Access Compliance Report

Public Rights-of-Way

(Curb Ramps)

Intersection ID: 14754	Main Street: SOUTH_BV	Cross Street: IVERSON_WY	Location: W
ADA ID: E9491C4C0478	Ramp Type: Perp	Initial Pass/Fail: Fail	Overall Compliance: No
		Severity Score: 12.5

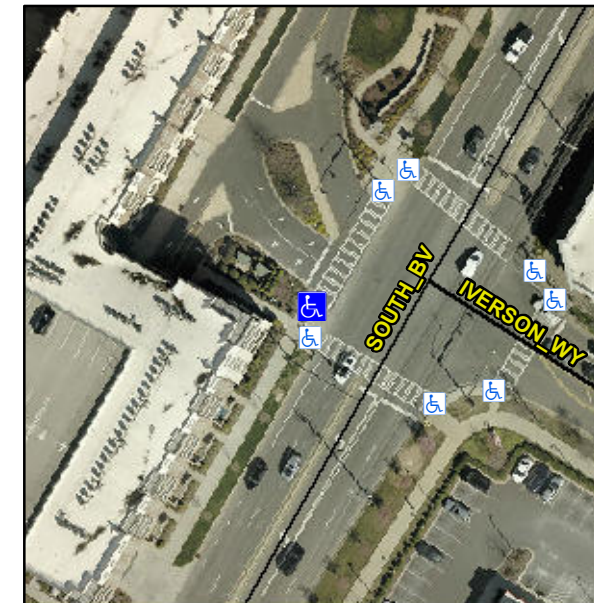
R304.2.2

Compliance	Description	Data	Compliance	Description	Data
N/A	Ramp Length (in)	73.0	No	Ramp Slope (%)	9.1
Yes	Ramp Width (in)	48.0	Yes	Ramp XSlope (%)	1.0
N/A	Flare Type LT	N/A	N/A	Flare Type RT	N/A
N/A	Flare Slope LT (%)	N/A	N/A	Flare Slope RT (%)	N/A
N/A	Flare Traversable LT?	N/A	N/A	Flare Traversable RT?	N/A
N/A	Landing Length (in)	N/A	N/A	DWS Provided?	N/A
N/A	Landing Width (in)	N/A	N/A	DWS Contrast?	N/A
N/A	Landing Slope (%)	N/A	N/A	DWS Length (in)	N/A
N/A	Landing X Slope (%)	N/A	N/A	DWS Full Width?	N/A
N/A	Landing Curb? (Y/N)	N/A	N/A	DWS Offset (in)	N/A
N/A	Shared Landing?	N/A			
N/A	Gutter Ponding?	N/A	N/A	Gutter Slope (%)	N/A
N/A	Gutter Lip Ht (in)	N/A	N/A	Gutter X Slope (%)	N/A
N/A	Painted X Walk1?	Yes	N/A	Painted X Walk2?	N/A
	X Walk 1 Direction	To NE		X Walk 2 Direction	N/A
N/A	X Walk 1 Width (in)	114.0	N/A	X Walk 2 Width (in)	N/A
	X Walk 1 Slope (%)	1.3		X Walk 2 Slope (%)	N/A
	X Walk 1 X Slope (%)	0.9		X Walk 2 X Slope (%)	N/A

Remove & Replace Entire Ramp.
